## Product Change Notification – 2016/04

Product Line:	etherCON cable carrier	Part No:	NE8MC*
Piece Part:	RJ45 guidance	Part No:	91226571 91226581 91226591 91111701
Engineering Change Notification:	154	Date:	15.12.2015
Comments:	The design of the RJ45 guidance has been improved.		
Affected products:	<ul style="list-style-type: none"><li>• NE8MC</li><li>• NE8MC-1</li><li>• NE8MC-1-D</li><li>• NE8MC-B</li><li>• NE8MC-B-1</li></ul>		
First Shipment of Modified Product:	I16 except NE8MC The NE8MC will be changed in the near future.

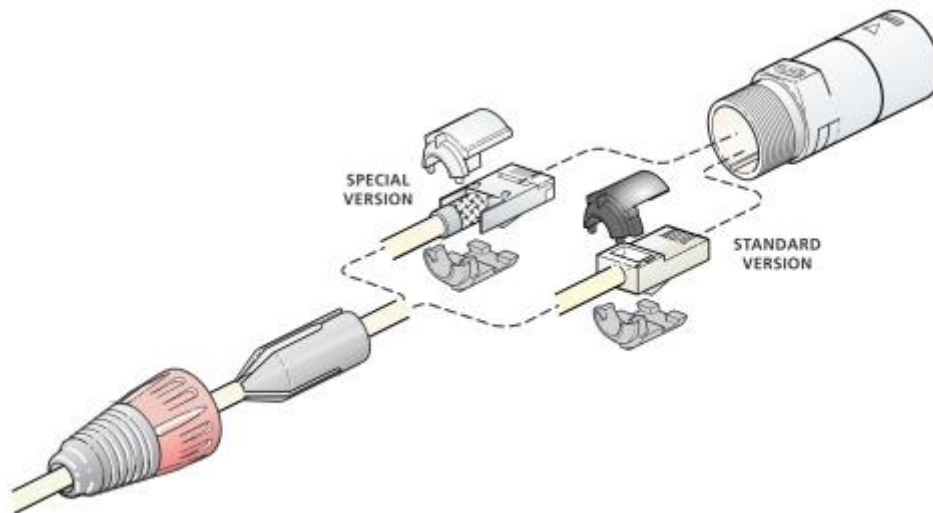
In order to provide a perfect fit for the vast amount of different RJ45s available on the market we have redesigned the alignment parts and simultaneously improved the positioning of the RJ45 connectors inside the etherCON cable carrier.

By help of the new alignment system we now support a greater range of RJ45 plugs while in parallel the improved positioning grants a smooth mating with the corresponding etherCON receptacle. Additionally, we significantly eased the assembly of the connector since the chuck now clasps around both alignment parts and so it is very convenient to insert the assembly group into the housing.
